5-9 Cowan Road St Ives SSDA Landscape Report - Response to Submissions

Prepared for Prosper
June 2026

DPHI Comments to RtS

Masterplan Comparison

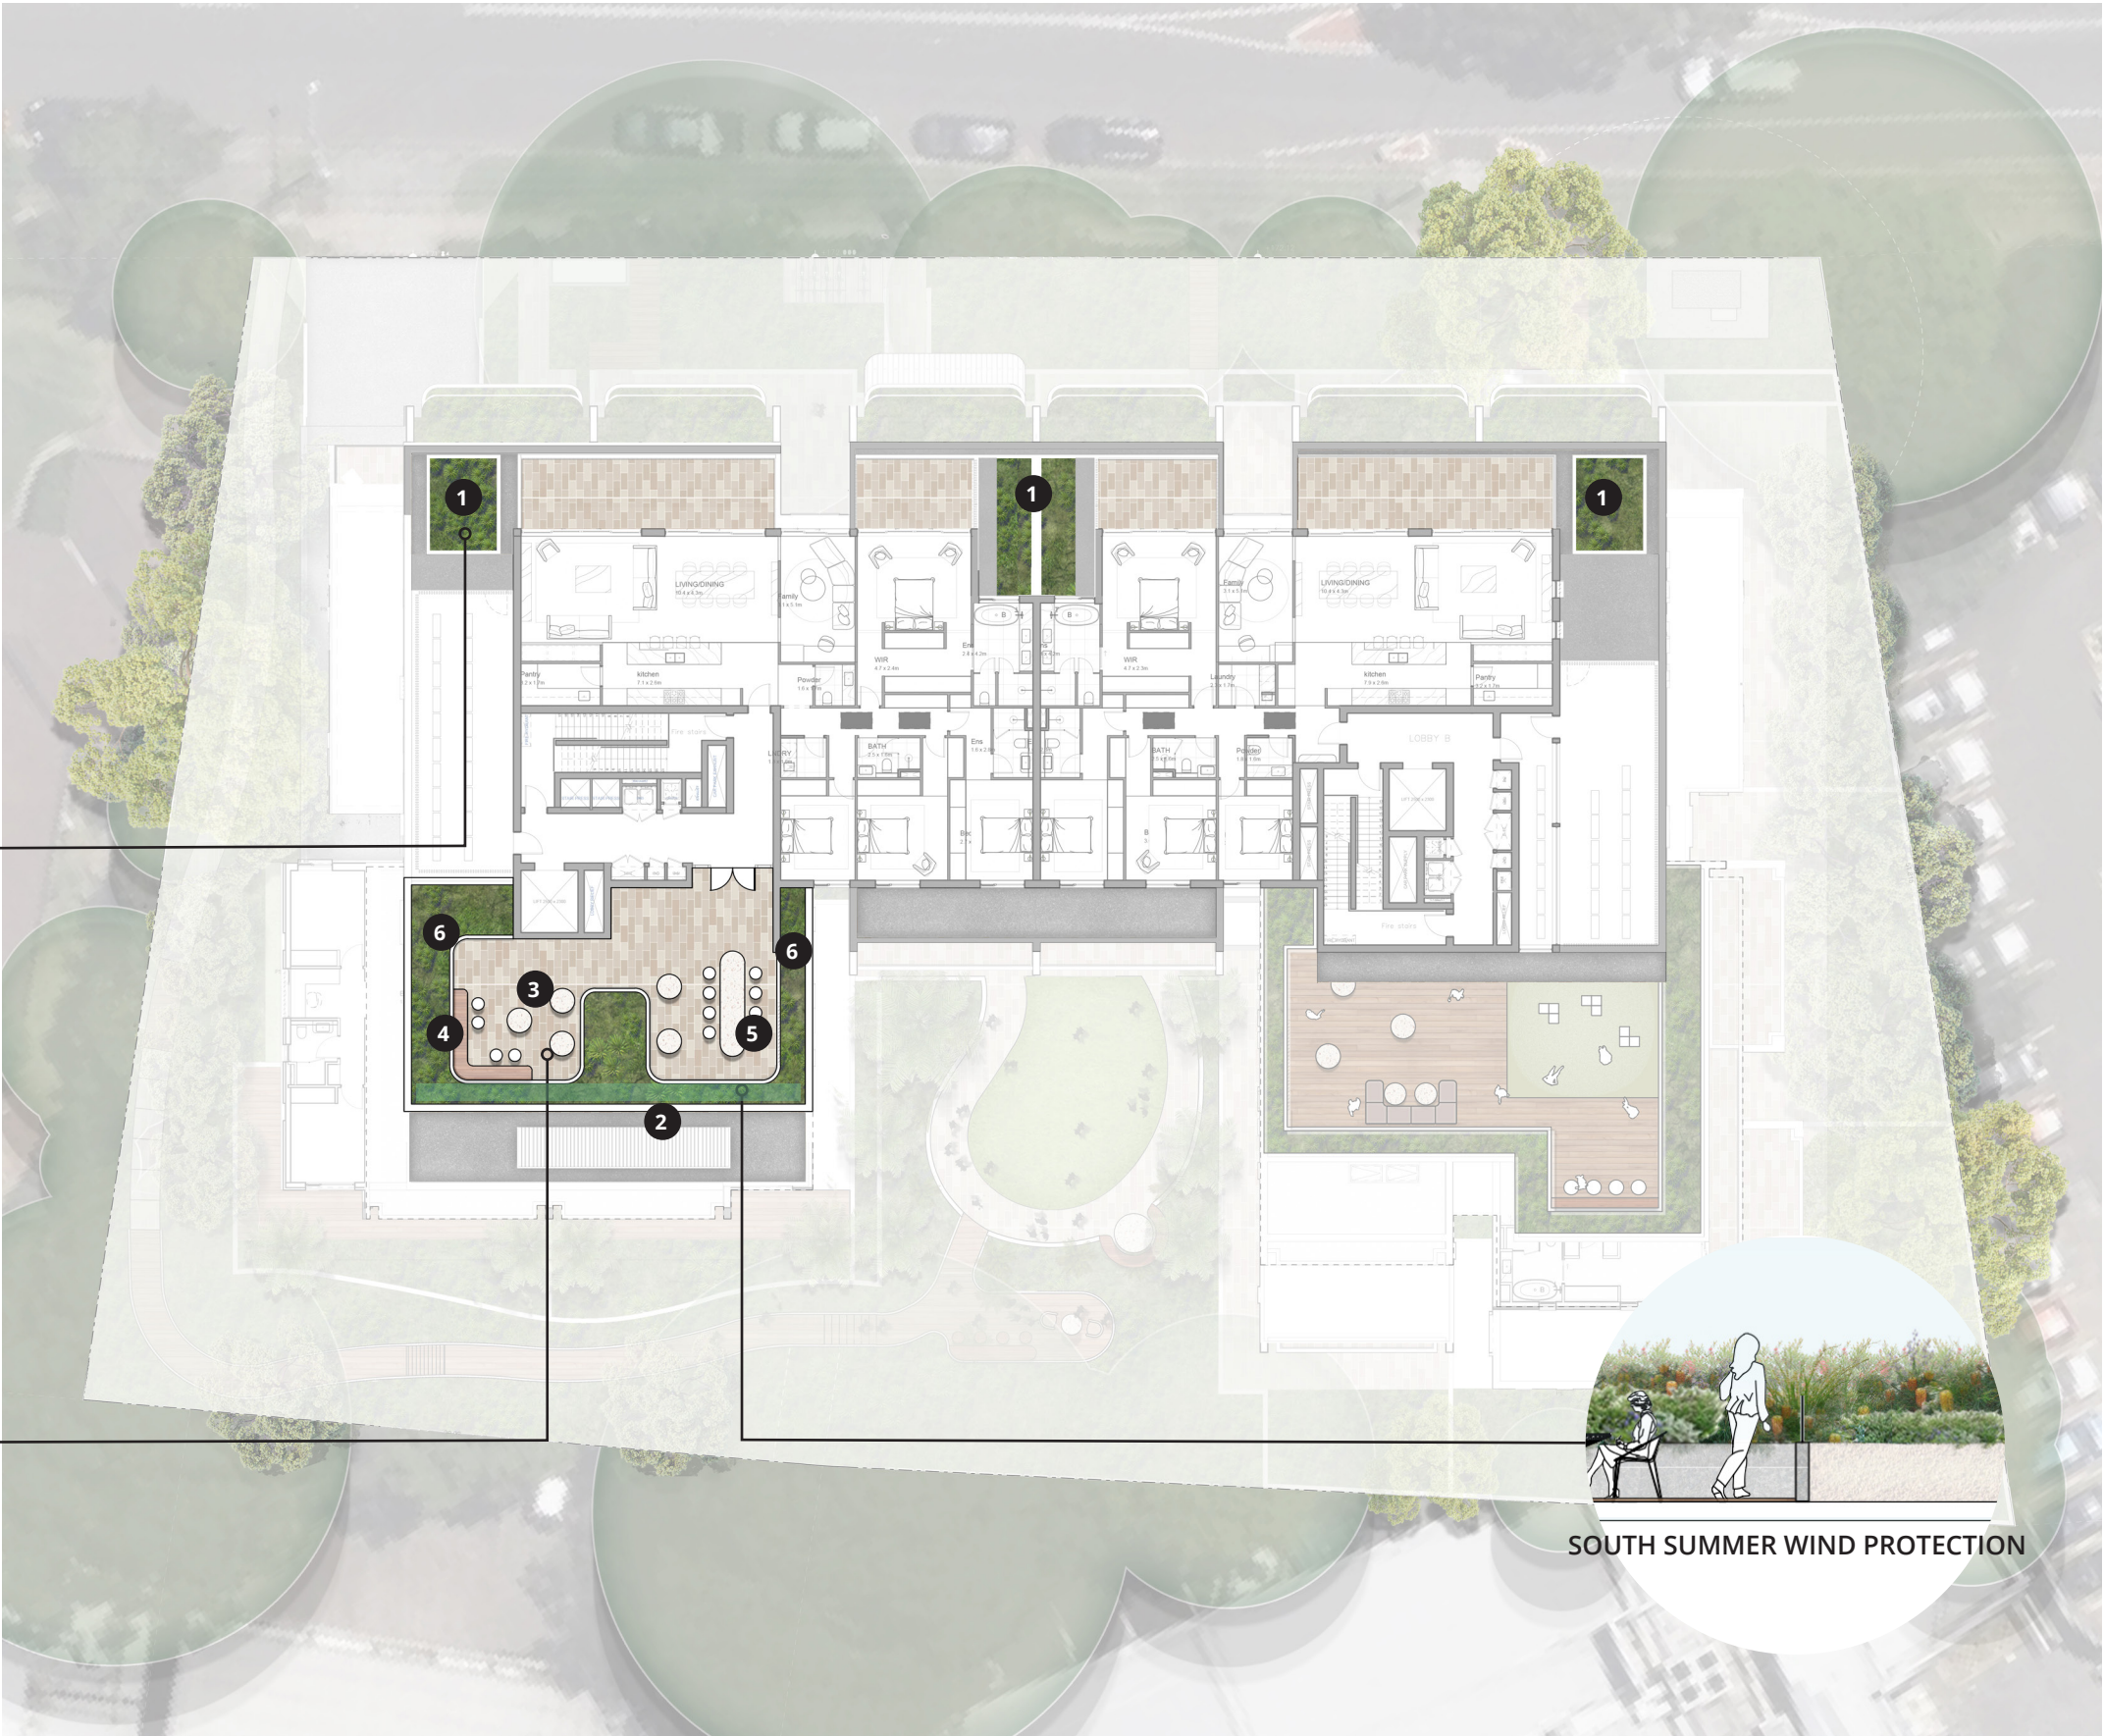
Review the planting to the level 7 communal open space to reflect the recommendations within the wind report. The following species as shown on the landscape plan are less than 1.5m in height (contrary to the wind report):

- DT, DC, GS, SW, MV and PX.

Ensure selected species exceed 1.5m in height to address wind mitigation recommendations.

Arcadia Comments: The planting design for the Level 7 communal open space was reviewed and updated in response to the wind report in the previous revision.

To address the southern summer wind condition identified in the report, while maintaining overall user experience, views, and comfort, MV (*Melaleuca viminalis*- Little John) is proposed along the outer edge of the southern raised planters to both the Level 7 and Level 8 communal open spaces.

As a small to medium shrub with strong flower colour, foliage texture, and year round structure, *Melaleuca viminalis* grow naturally to approx 1-1.2m in height. Planted within the 500mm raised planter, it contributes to achieving the required minimum 1.5m height above the communal open space FFL along the southern perimeter, as identified in the wind report, thereby improving wind mitigation and overall user comfort.

In relation to the north-east wind condition identified in the wind report, both Level 7 and Level 8 communal open spaces are generally screened by the building massing and are therefore largely protected from north-east winds.

Refer to Pg. 25-26 Level 7 Masterplan and Section, and landscape documentation package.

Tree Removal and Replacement Plan

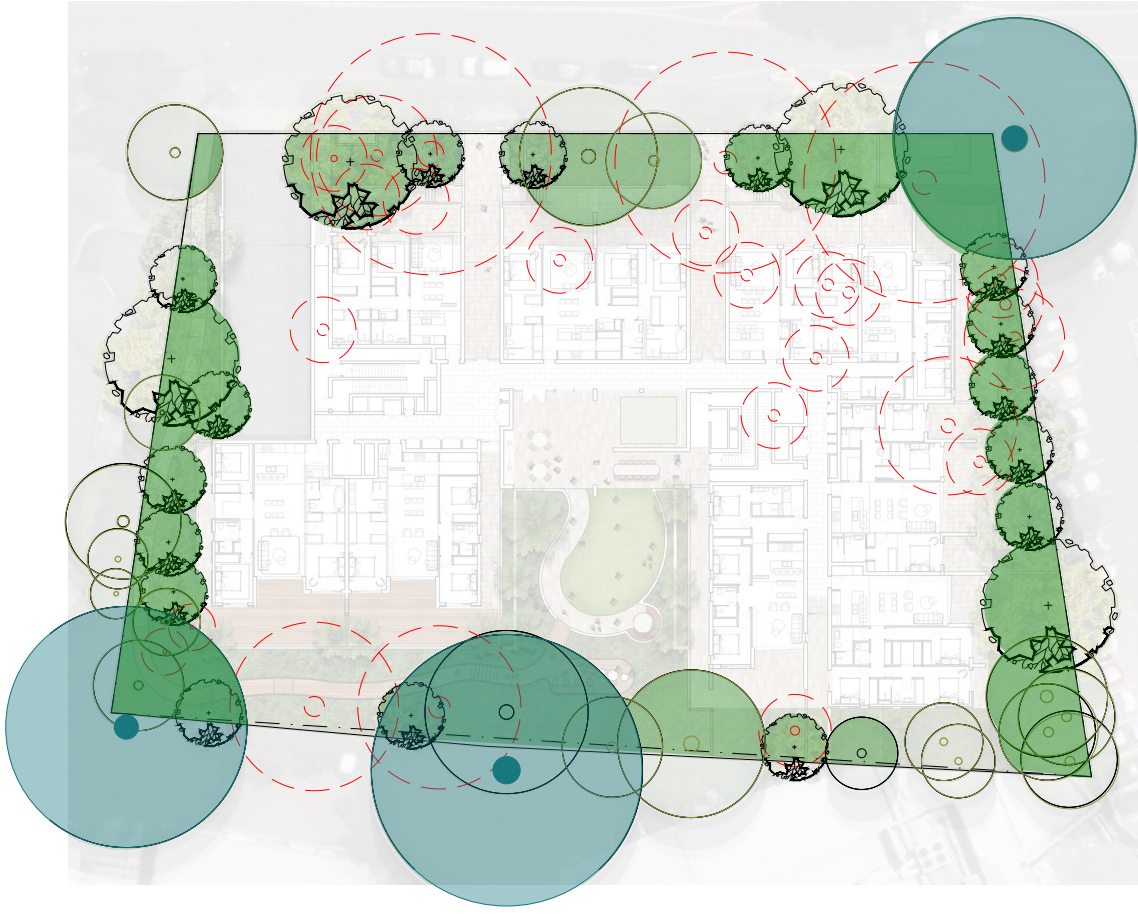
Only trees 16 and 24 are proposed to retained. Trees 2, 15, 18 and 19 are still proposed to be removed.

Arcadia Comments: The proposal has been revised to retain four of the six trees originally identified for removal, being T15, T16, T18 and T24, which together maintain continuity of canopy cover and streetscape character.

Two of the six trees are indentified for removal - T2 *Lophostemon confertus* (Brush Box) and T19 *Melaleuca myrtifolia* (Sweet scented Paperbark).

T2 – *Lophostemon confertus* (Brush Box)

T2 is located within the proposed building footprint and conflicts with substation location. Retention is not feasible. It is proposed to be removed and replaced with a Turpentine (*Syncarpia glomulifera*), a locally native species that thrives in a similar growth habitat and contributes to the desired long-term streetscape canopy.

T19 – *Melaleuca myrtifolia* (Sweet scented Paperbark)

T19 is located within the proposed building footprint and conflicts with the new fire sprinkler and hydrant booster infrastructure. Retention is not feasible due to very limited space for the new essential services along the street interface. Its removal will have minimal impact on the established street character or overall canopy structure. It will be replaced with a Lilly Pilly (*Acmena smithii*).
